**ADDENDUM NO. 1
TO THE CONTRACT DOCUMENTS**

**Humboldt Community Services District
5055 Walnut Drive
Eureka, CA 95503**

WALNUT DRIVE UTILITY EARTHQUAKE RECOVERY & RESILIENCE PROJECT

HCSD water maps
for slide area and
surrounding
neighborhoods.
Not to scale

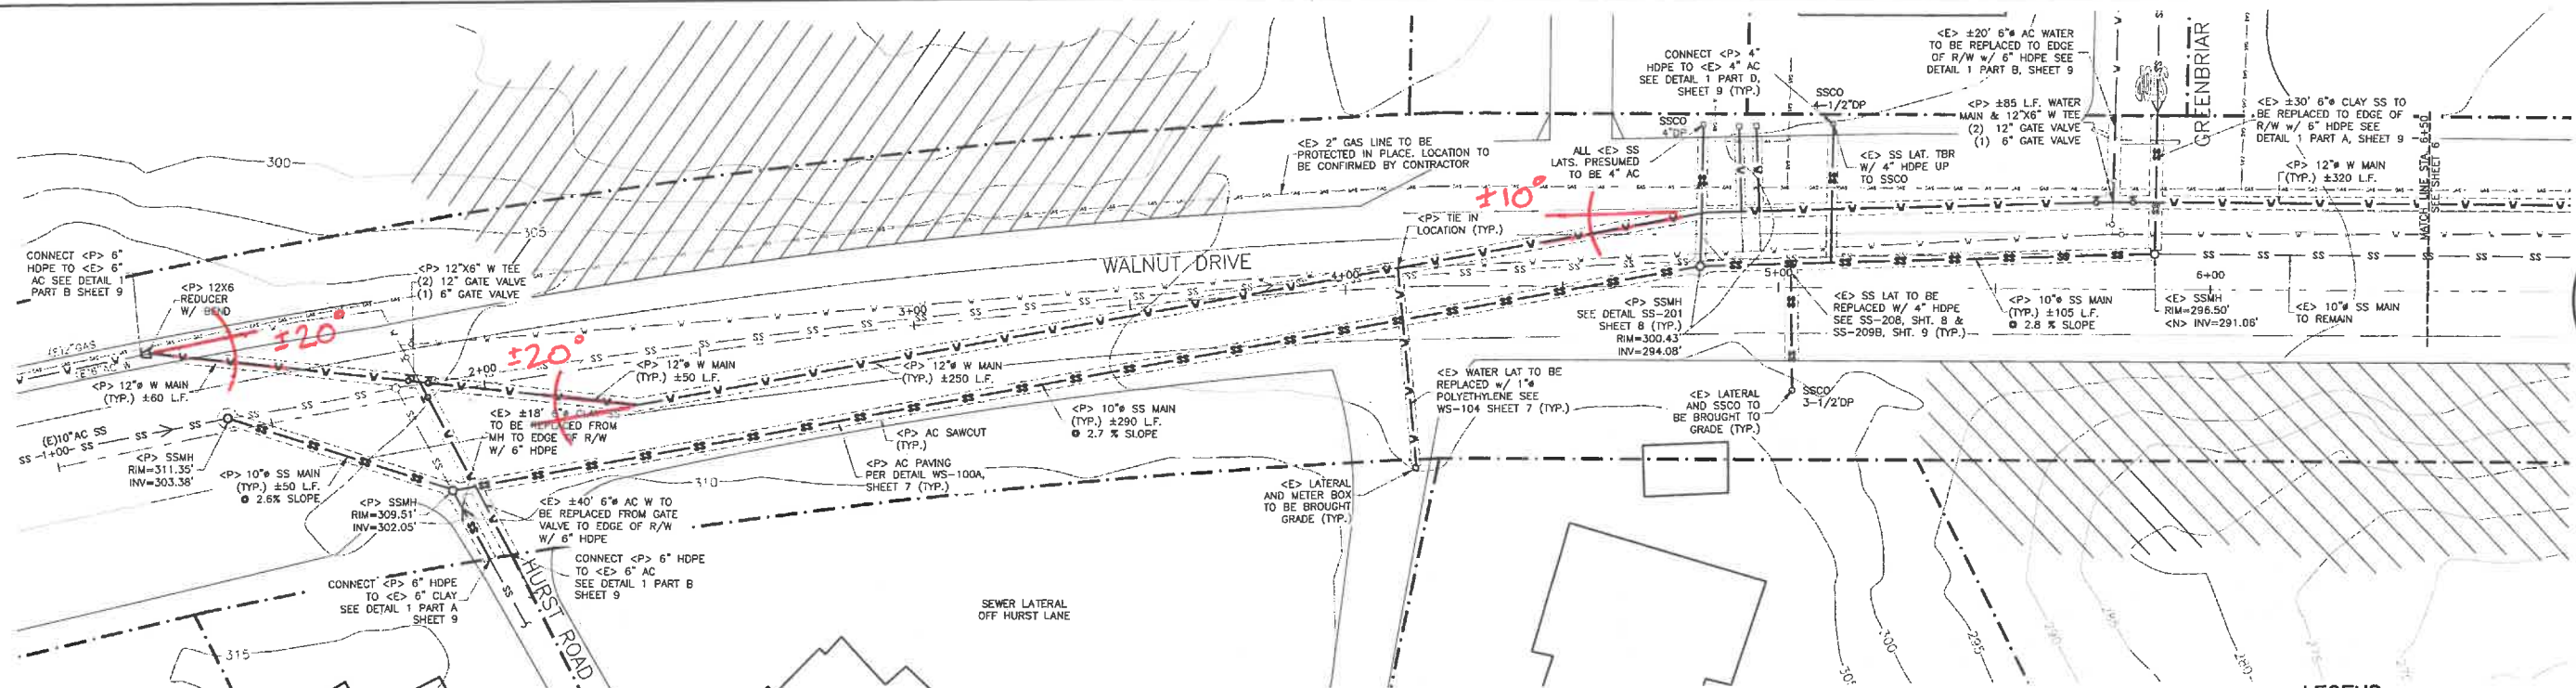
- Q7. Can you provide a larger zoomed out map/line work for reference of existing sewer and water connections showing the whole project area which may be affected by construction?

- A7. Yes, two attachments containing a PDF of the greater project extents shall be posted to the District Public Notices page along with this response to RFI's. The first attachment labeled "Walnut Drive Earthquake Recovery and Resilience Project Sewer Map" shall show the sewer infrastructure and the second will be water infrastructure labeled "Walnut Drive Earthquake Recovery and Resilience Project Water Map".

Date	JULY 15, '24
Scale	AS NOTED
Design	ZDJ
Drawn	ALW
Job	HCD 2303
Sheet	5

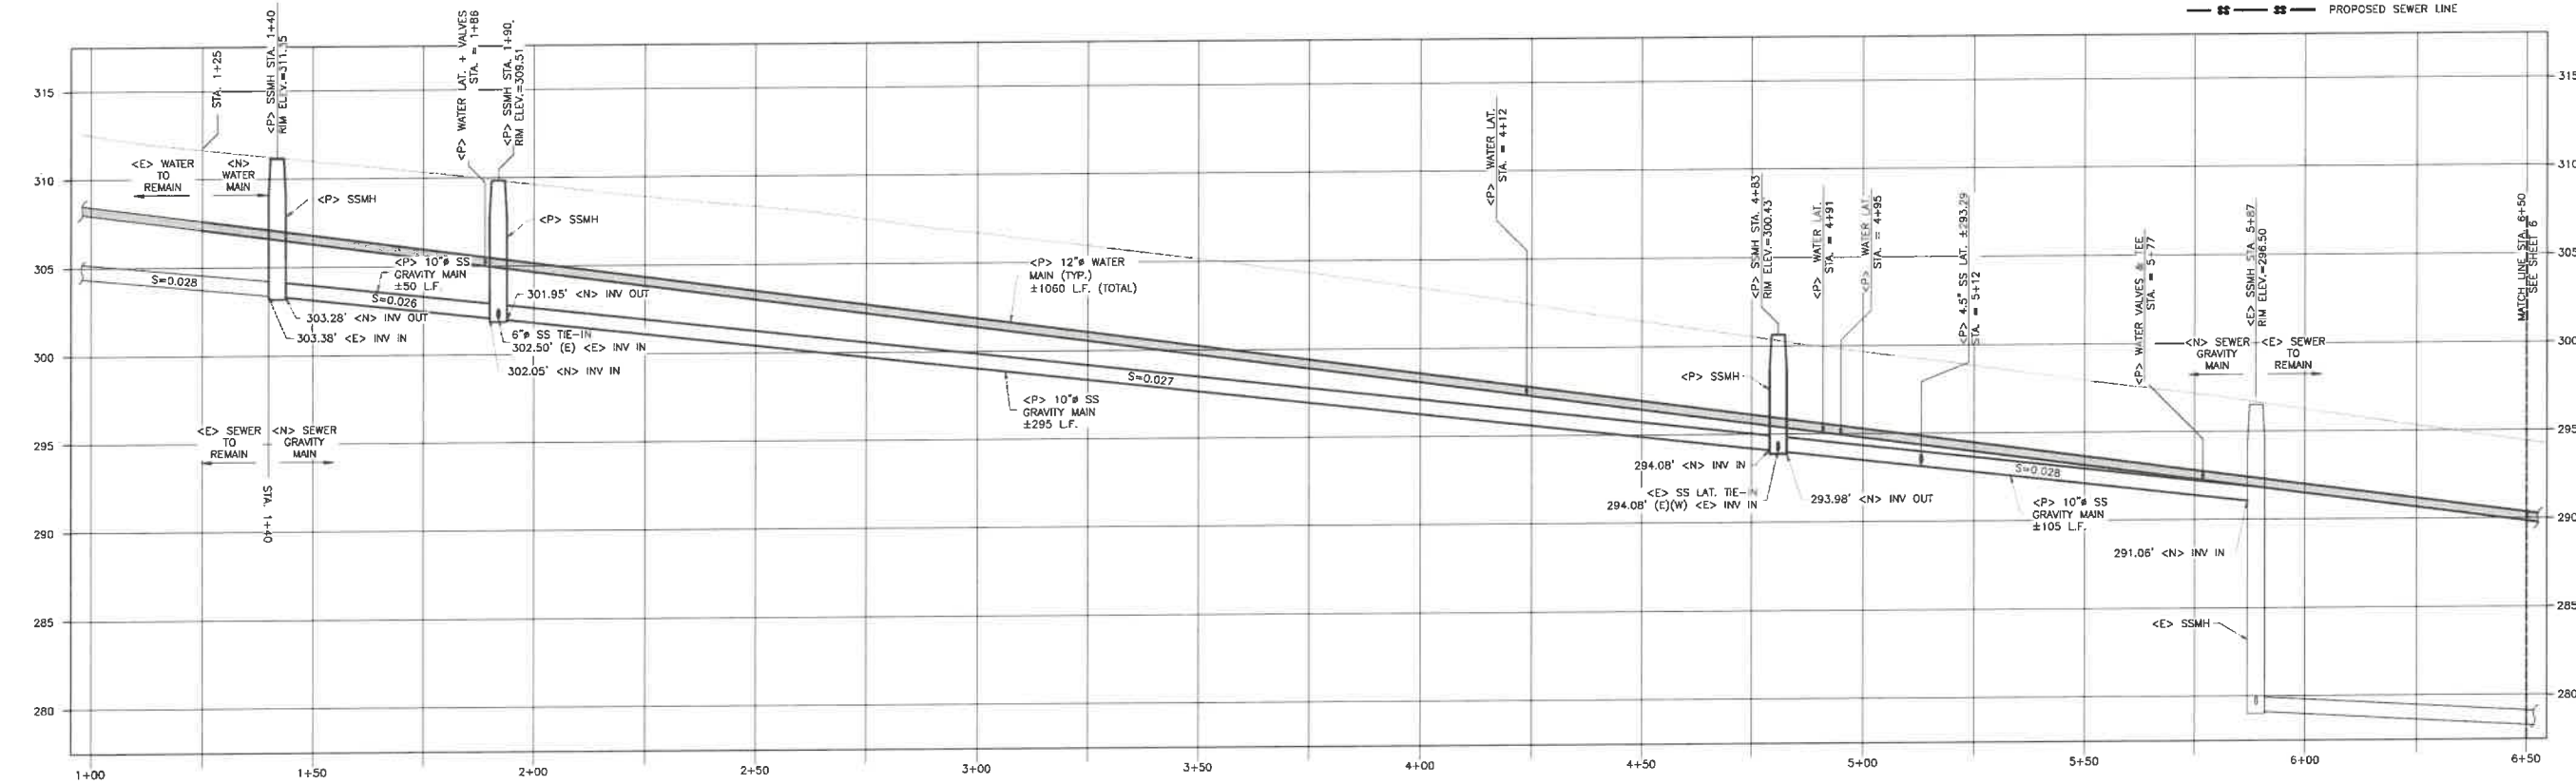
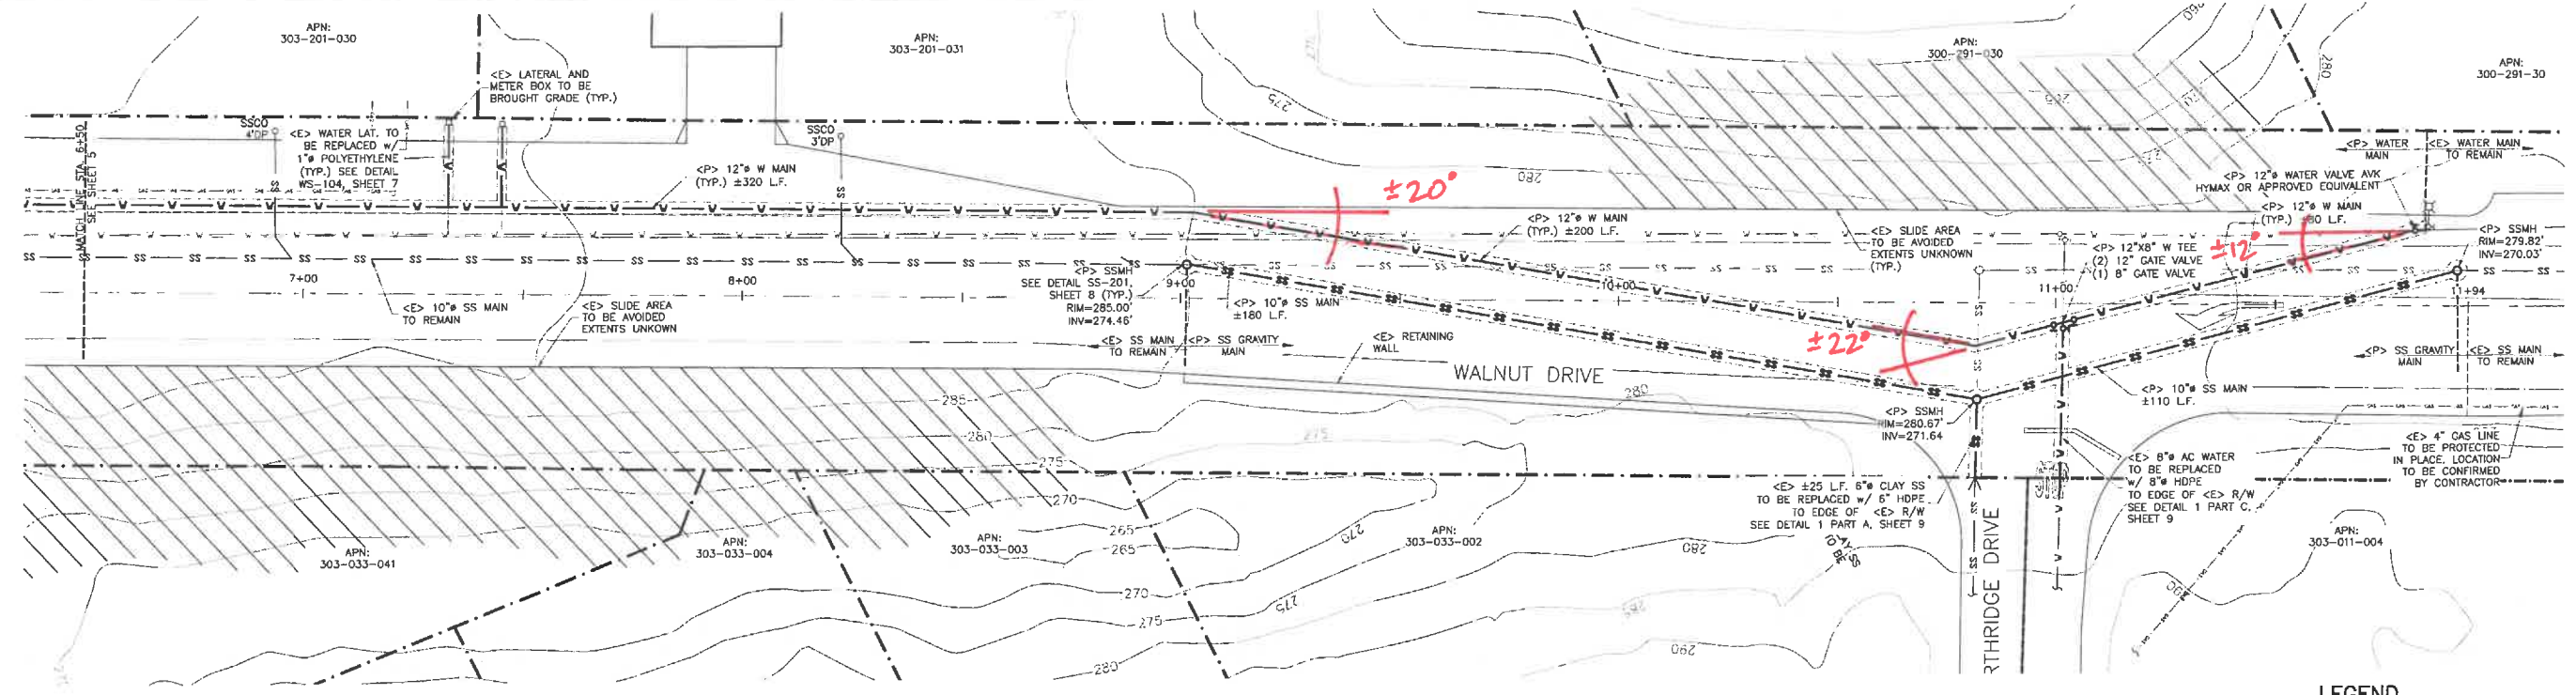
- Q19. What are the bend angles (not called out on the plans)?
- A19. Please reference attachment "Bend Angles Walnut Drive Earthquake Utility Recovery and Resilience".

ADDITION – “Bend Angles Walnut Drive Earthquake Utility Recovery and Resilience” containing the bend angles not called out in the plans is attached and shall be considered part of this Addendum. (2 pages)
